Notice of Meeting

Lindon City Planning Commission

Item 4: Preliminary Approval for a Three Lot Minor Subdivision and Site Plan Approval — Mountain Tech South Approximately 400 N. 2800 W.

Item 5: Site Plan — Autumn Grove 1550 W. 100 S.

1 NORTH AND SOUTH ELEVATIONS
A104 3/32" = 1'-0"

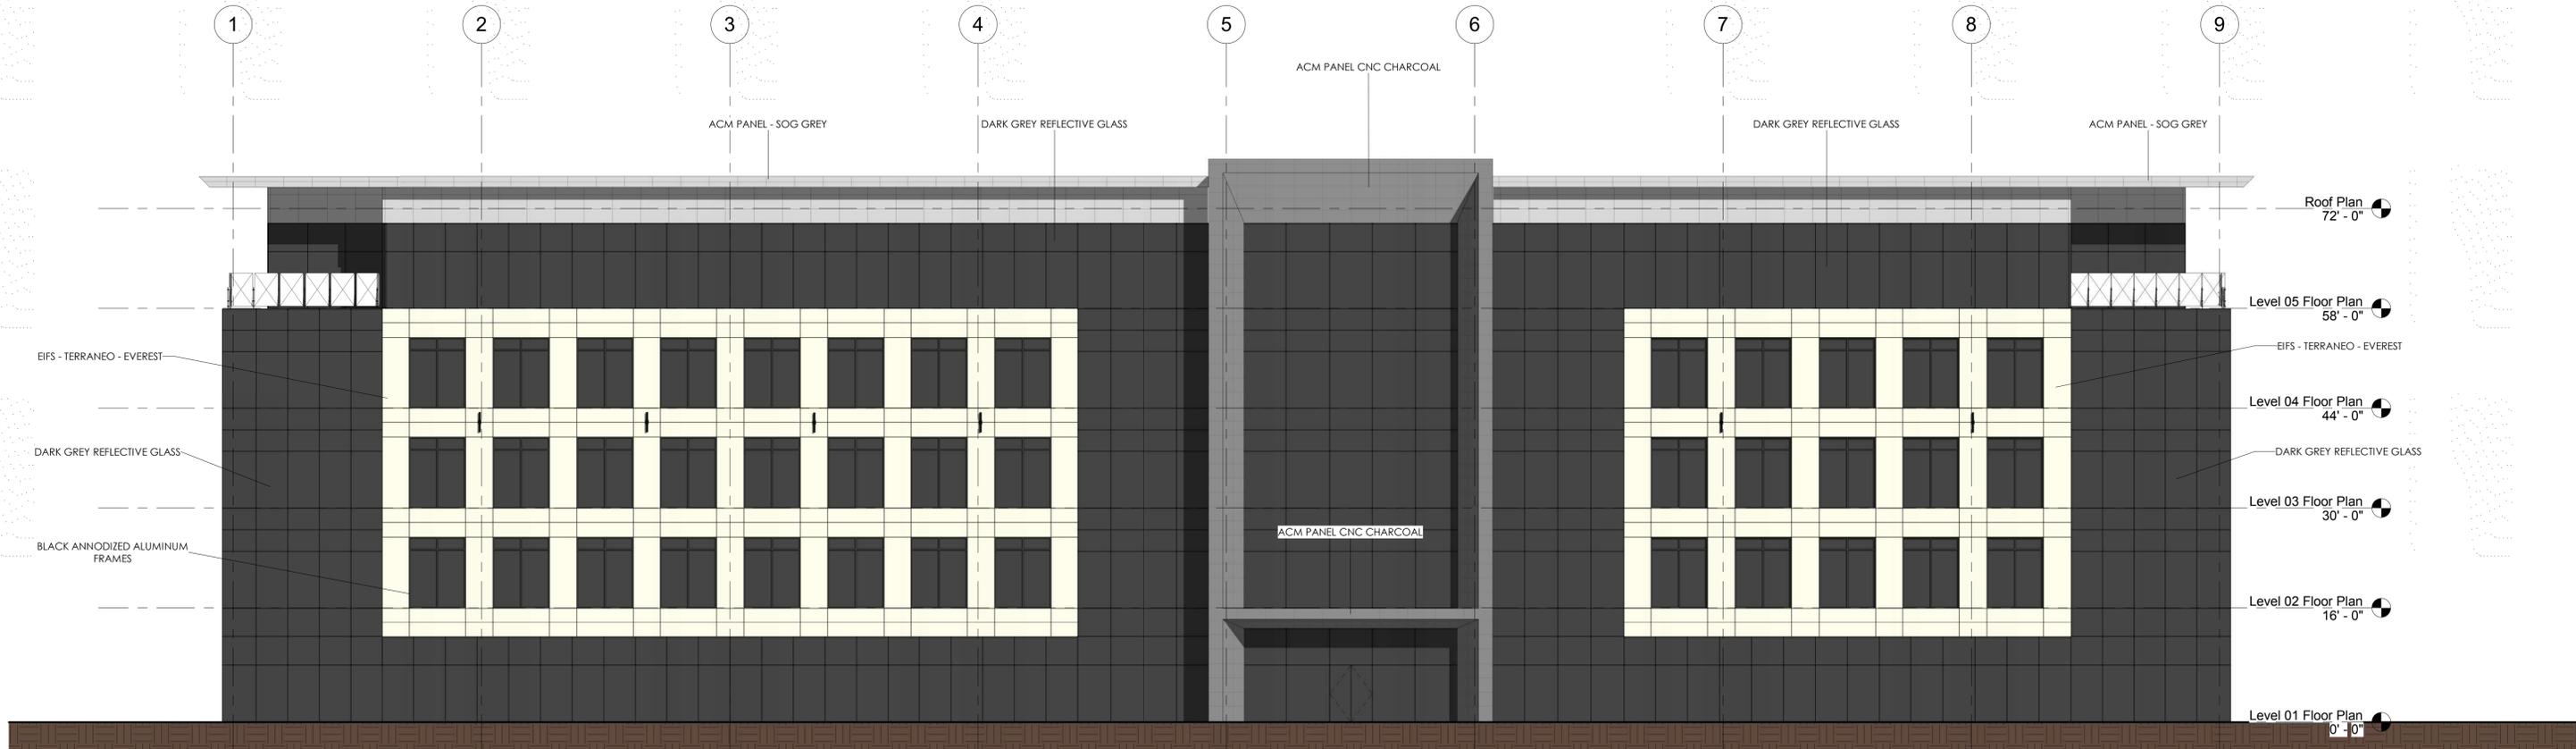
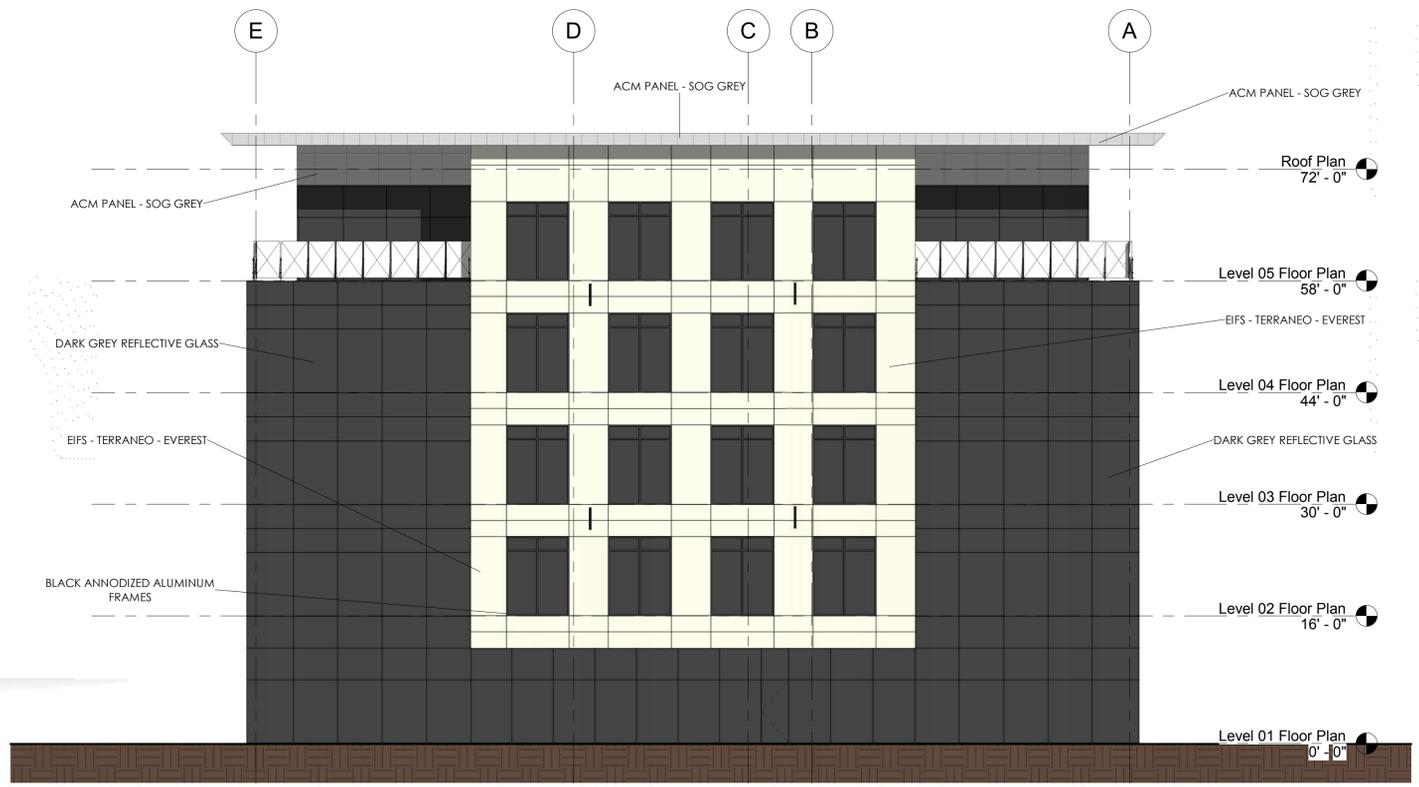
The office building is a five-story structure with three main architectural materials which include glass, architectural metal panels and stucco. The entrance is identified with an architectural metal element. Below are a few items that staff has identified in relationship to the design of the building that the planning commission will need to consider as found in 17.54.050:

- *On buildings 20,000 sq. ft. or more the façade should be broken up every 50 feet with color, change of building materials, depth, height, or other architectural characteristics. 17.54.050(1a)*

Staff believes that this development will be an amenity to Lindon City for providing increased employment opportunities and a varied tax base. The buildings need to show additional architectural detail and should be evaluated for compliance with architectural design requirements in title 17.54.050. In addition, proper site design needs to be evaluated specific to meeting minimum landscape standards as well as compliance with traffic circulation. Finally, the commission should also evaluate the applicant's proposal for increased parking ratios for the sites.

MOUNTAIN TECH SOUTH PARKING STRUCTURE

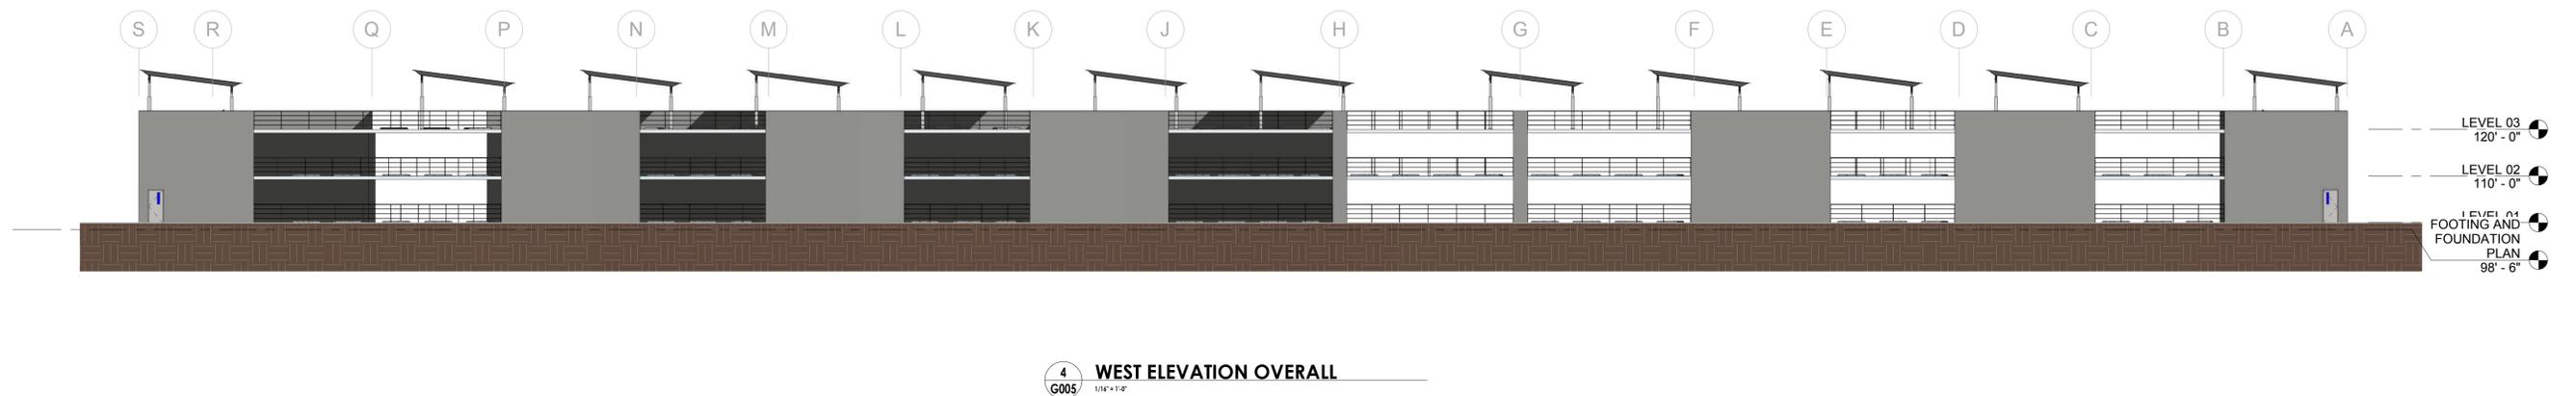
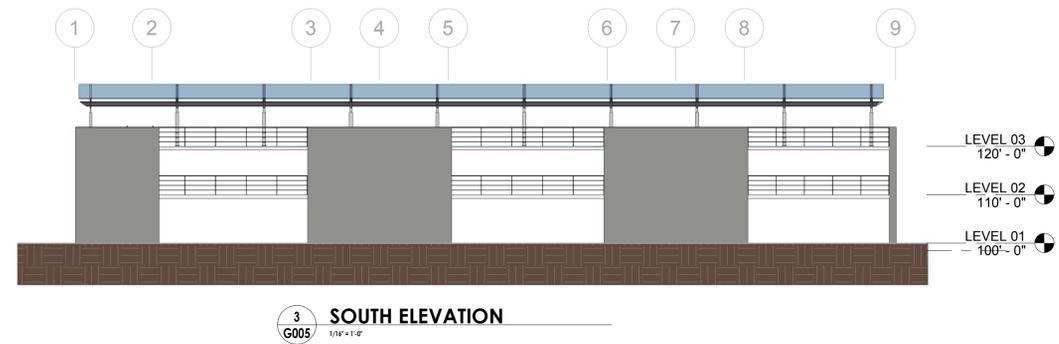
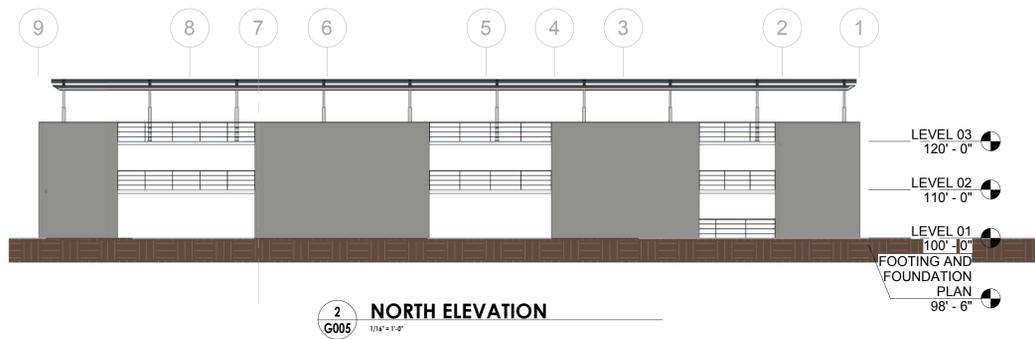
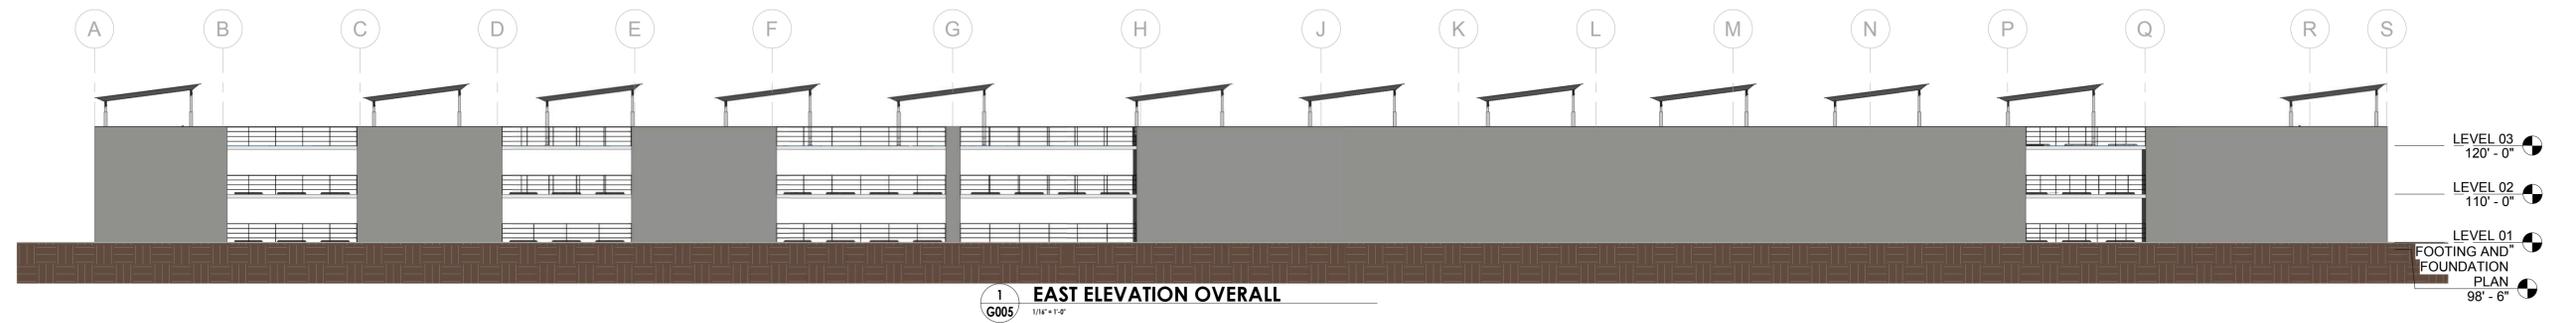
The applicant's proposal includes a three-story parking structure for 615 vehicles. The applicant is also proposing that solar panels be placed on top of the parking structure to support sustainability of the site. Below are a few items that staff has identified in relationship to the design of the building that the planning commission will need to consider as found in 17.54.050:
